Re: 180/400 Draft GSP (comments on errata)

To: Salinas Valley Basin Groundwater Sustainability Agency (GSA)

Re: November 14, 2019 Board of Directors Meeting  
Item 4., General Public comment and Item 7.a, Initial Concepts on  
Planning Actions and Implementation of the 180/400 Aquifer Draft  
Groundwater Sustainability Plan (GSP)

**Figure 1.** GDE Pulse web viewer screenshots of satellite-based trends of vegetation growth (NDVI), moisture (NDMI), shallow groundwater levels, and precipitation for selected vegetation from the NC dataset in the 180-400 Foot Aquifer area.

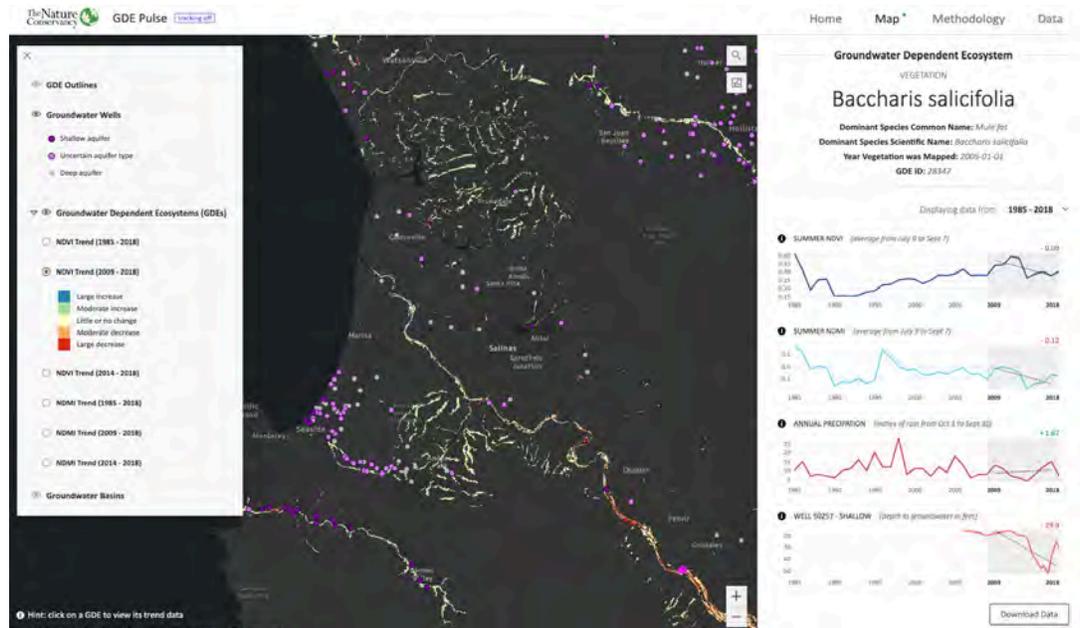
- The [GDE Pulse](#) web application developed by The Nature Conservancy provides easy access to 35 years of satellite data to view trends of vegetation metrics, groundwater depth (where available), and precipitation data. This satellite imagery can be used to observe trends for NC dataset polygons within the 180-400 Foot Aquifer area (Figure 1). Over the past 10 years (2009-2018), NC dataset vegetation polygons have experienced adverse impacts to vegetation growth and moisture which are correlated to declines in groundwater levels (e.g., as indicated by wells GZWA21202, CHEA21208).

**Figure 1 - Seawater Intrusion SMCs Relative to Domestic Wells, Public Supply Wells, DACs, and Community Water Systems Salinas Valley Basin GSA**

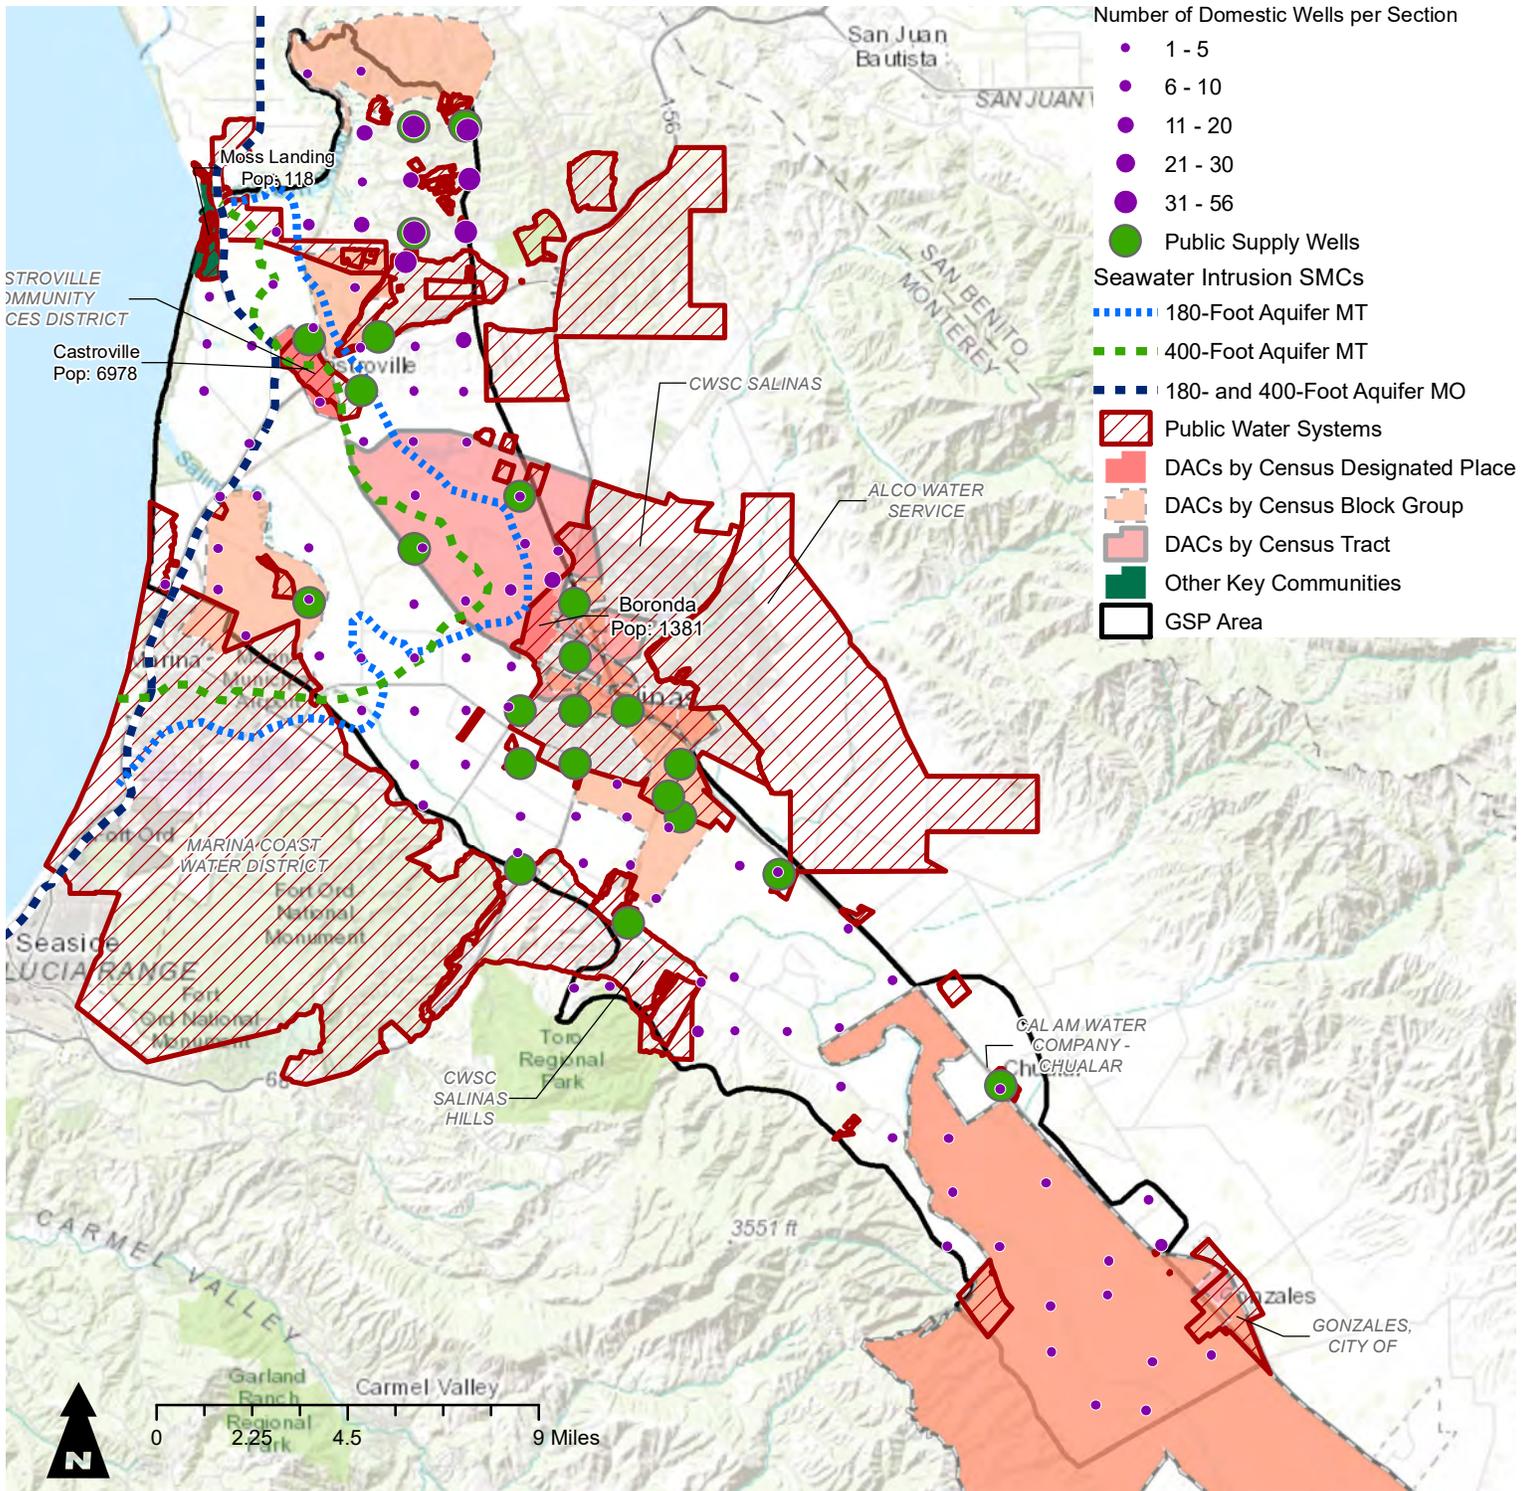
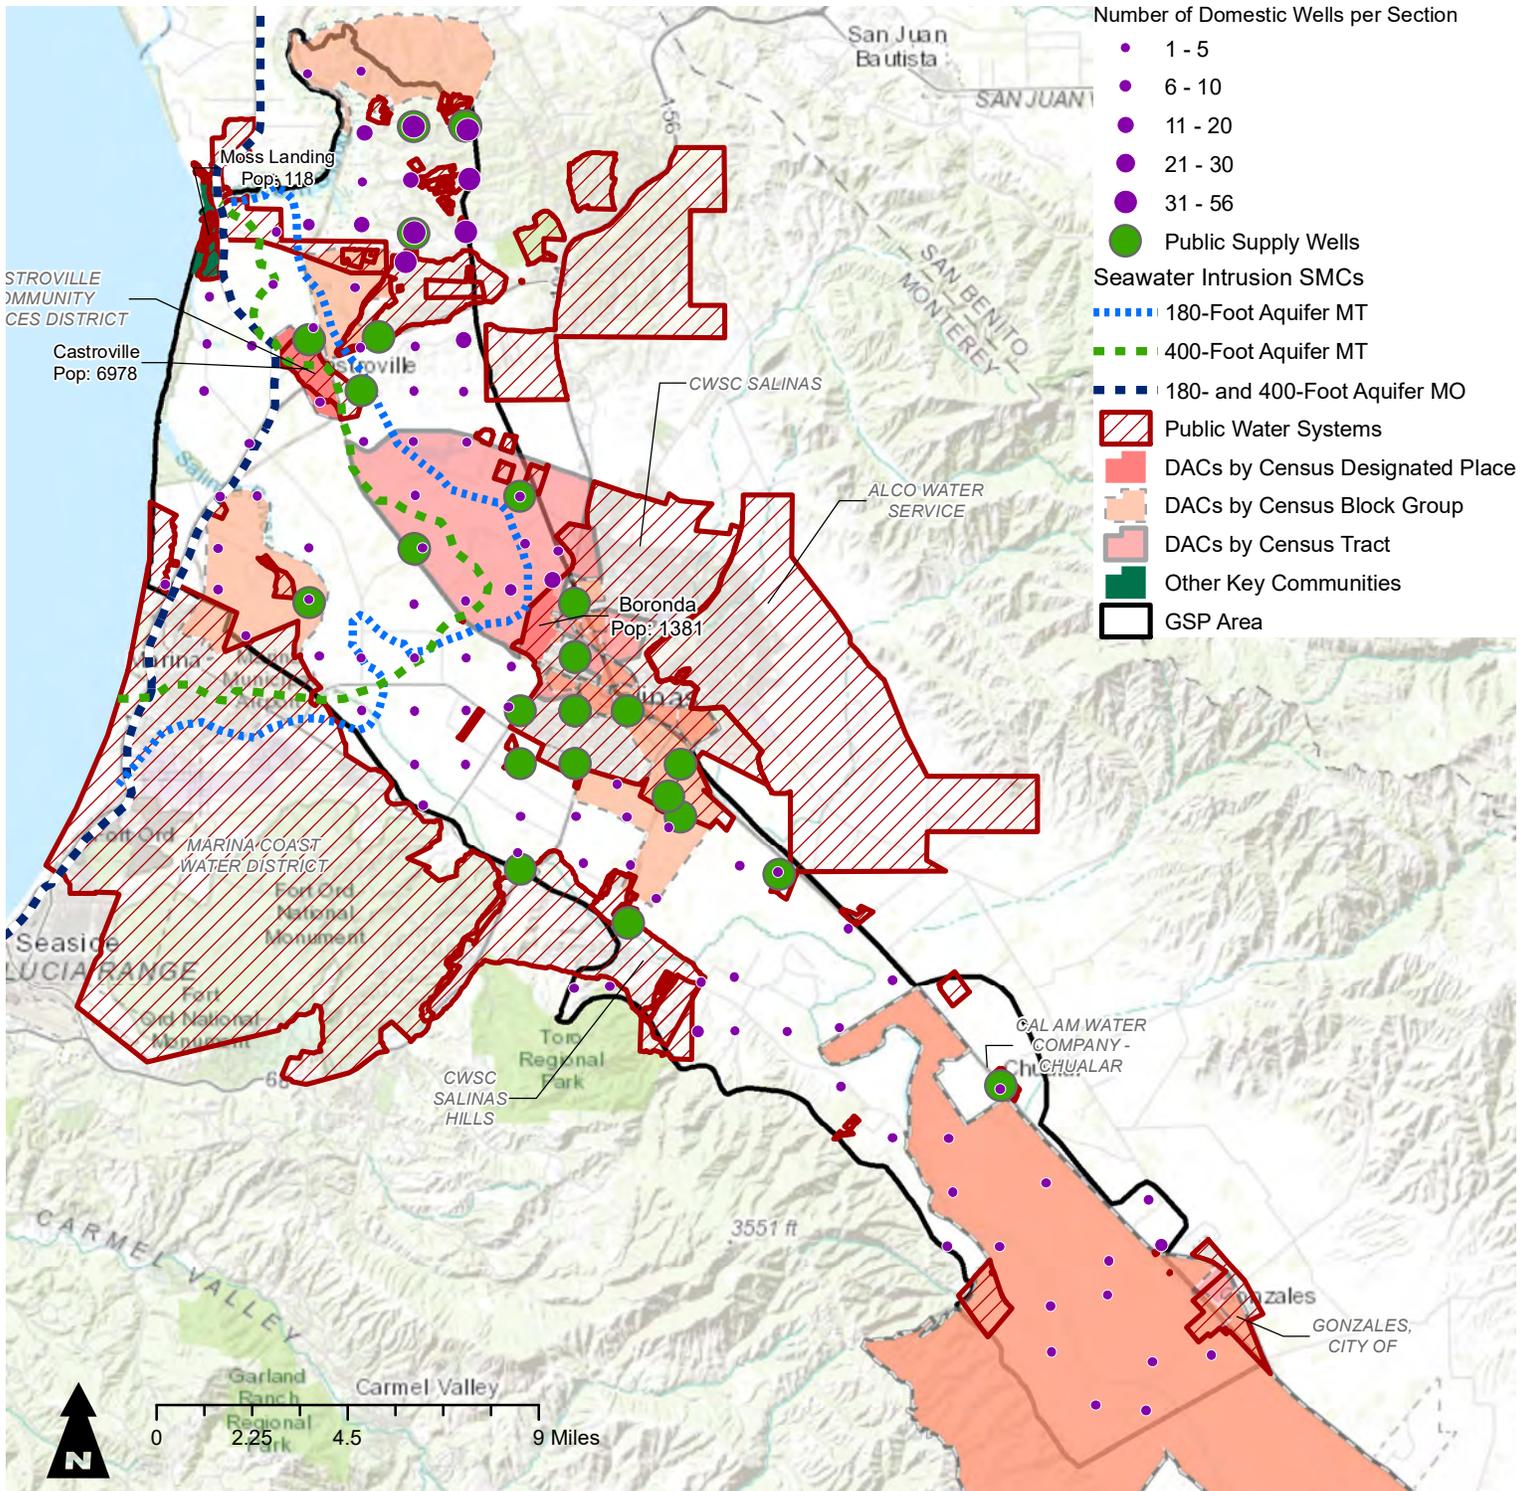
As shown on **Figure 1**, a significant proportion of the 180/400-Foot Aquifer Subbasin (subbasin) is designated as Disadvantaged Communities (DACs), totaling a population of roughly 50,000 people based on DWR-provided Census data.<sup>1</sup> Members of these DACs and other communities receive their drinking water from roughly 500 domestic wells located within the subbasin and a variety of public water systems, including approximately 30 separate community water systems.

**Figure 1** also shows the proposed Minimum Threshold (MT) contours for seawater intrusion for the 180-Foot and 400-Foot aquifers. According to Section 8.8.2 of the draft GSP, these MT contours represent “the 2017 extent of the 500 mg/L [milligrams per liter] chloride concentration isocontour as mapped by MCWRA [Monterey County Water Resources Agency],” and thus represent near-current seawater intrusion conditions. Based on these data, a significant portion of the drinking water supply in the subbasin is at imminent risk of seawater intrusion impacts if seawater intrusion is not halted, including: 1) a high concentration of domestic well users located east of Moss Landing and north of Castroville, 2) domestic well users in and around the DAC of Boranda, 3) public supply wells located near Castroville (a DAC), and 4) public supply wells located near Salinas (which includes DACs). **For the reasons discussed further below, the draft GSP does not lay out a clear and robust plan to achieve sustainability, and protect drinking water for these vulnerable beneficial uses and users.**

**Chart 1 – Hydrograph of Deep Aquifer Well**

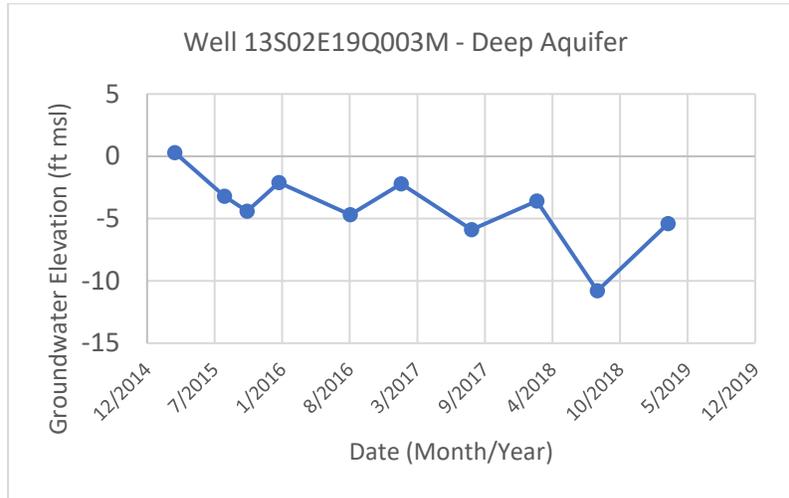
**Groundwater Sustainability Agency (SVGSA) should work to fill this data gap and at a minimum, should include the limited available data in the draft GSP.**

Figure 5-3. August 2017 180-Foot Groundwater Level Contours

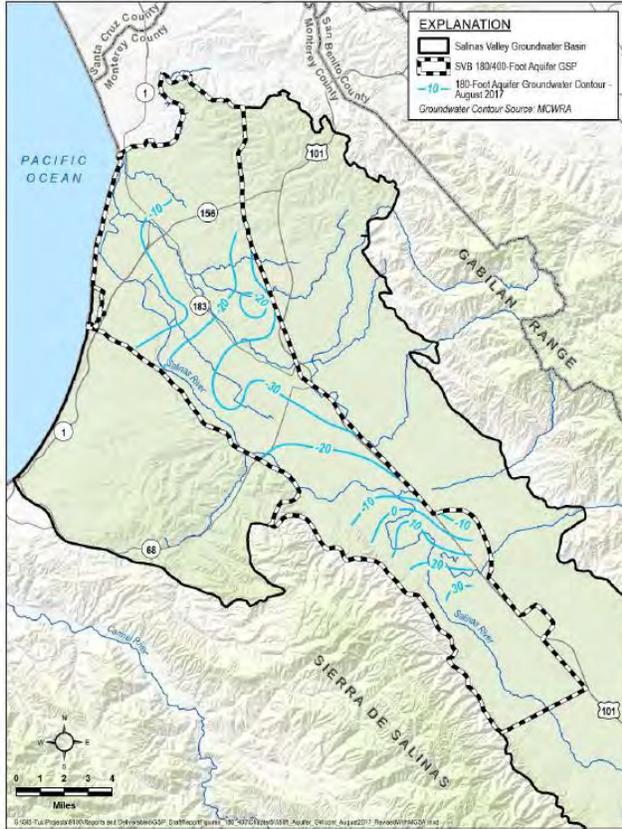
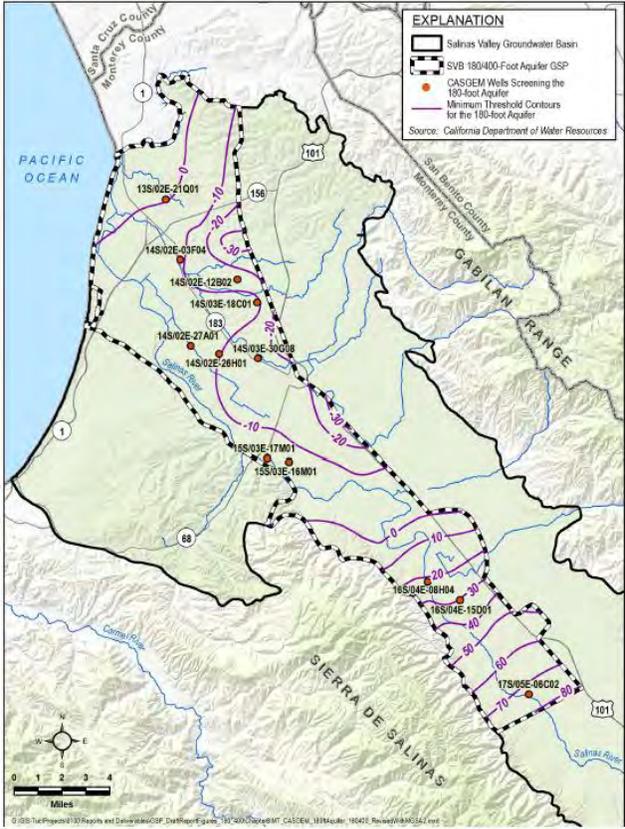
**Comparison of Current Water Level Gradient to MT Water Level Gradient – 180-Foot Aquifer**

Figure 5-5. August 2017 400-Foot Aquifer Groundwater Level Contours

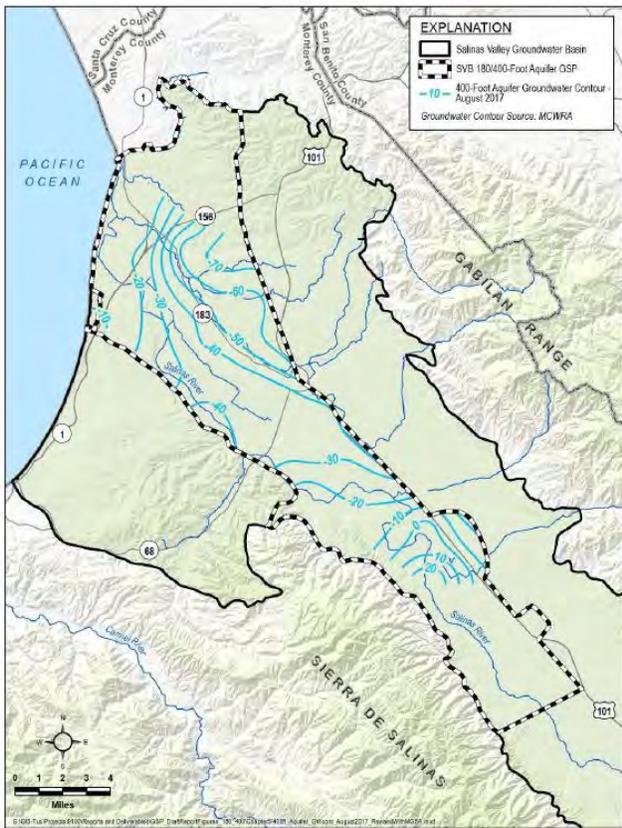
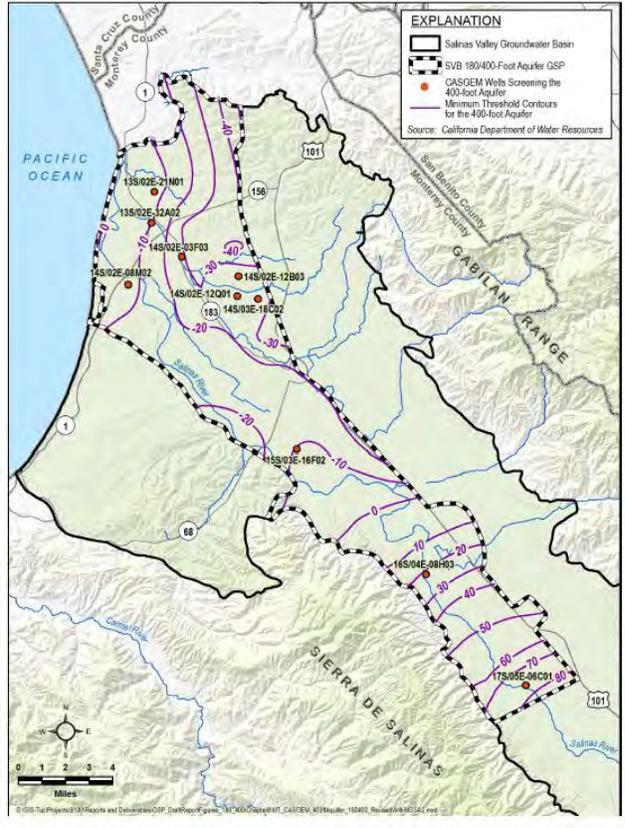
**Comparison of Current Water Level Gradient to MT Water Level Gradient – 400-Foot Aquifer**
